AMENDMENT OF SOLICITATION/MODIFICATION OF CONTRACT			1. CONTRACT ID CODE	PAGE OF PAGES	
			J	1	7
2. AMENDMENT/MODIFICATION NO. 0008	3. EFFECTIVE DATE 16-Jul-2004	4. REQUISITION/PURCHASE REQ. NO. W16ROE-4068-6489		5. PROJECT NO.(If applicable)

14. DESCRIPTION OF AMENDMENT/MODIFICATION (Organized by UCF section headings, including solicitation/contract subject matter where feasible.) The purpose of this amendment is: 1) To incorporate questions and answers. Answers are for informational purposes only. 2) To incorporate updated wage rates The proposal due date remains unchanged, 26 July 2004 at 2:00pm local time. All other terms and conditions remain unchanged as a result of this amendment. NOTE: Bidders must acknowledge receipt of this amendment by the date specified in the solicitation (or as amended) by one of the following methods: In the space provided on the SF 1442, by separate letter, or by telegram, or by signing the block 15 below. FAILURE TO ACKNOWLEDGE AMENDMENTS BY THE DATE AND TIME SPECIFIED MAY RESULT IN REJECTION OF YOUR BID IN ACCORDANCE WITH THE LATE BID, LATE MODIFICATIONS OF BIDS OR LATE WITHDRAWAL OF BIDS (FAR 14.304) Except as provided herein, all terms and cond

Δ 7/13/04
WITH ITEM 039 & 072
Item 039A

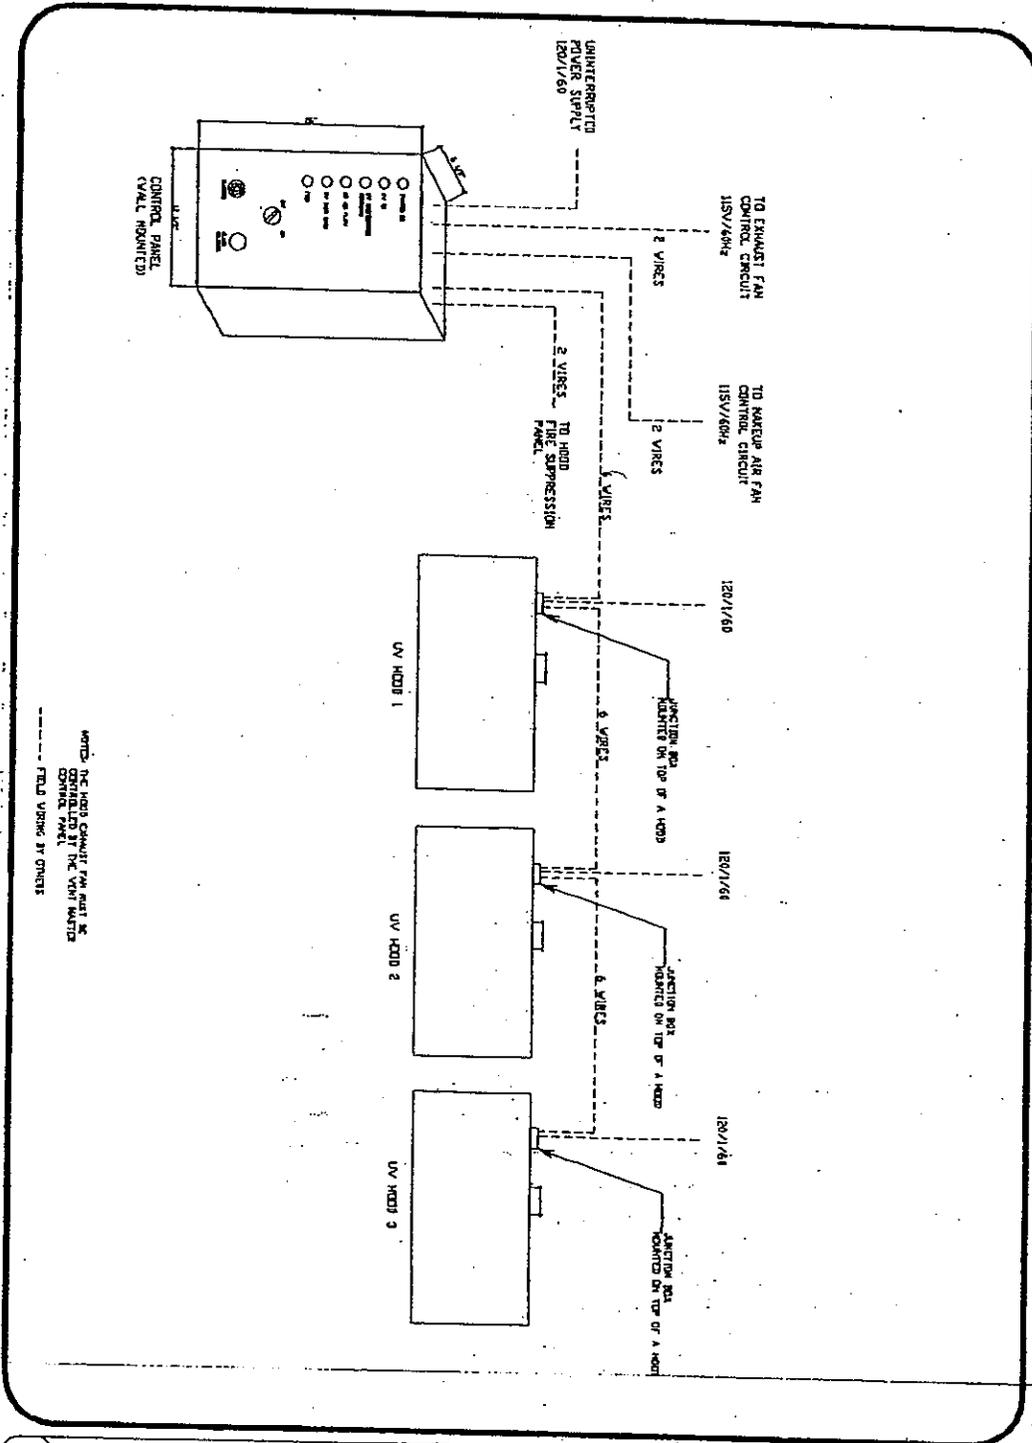
IN CONJUNCTION WITH
ITEMS 039A
041
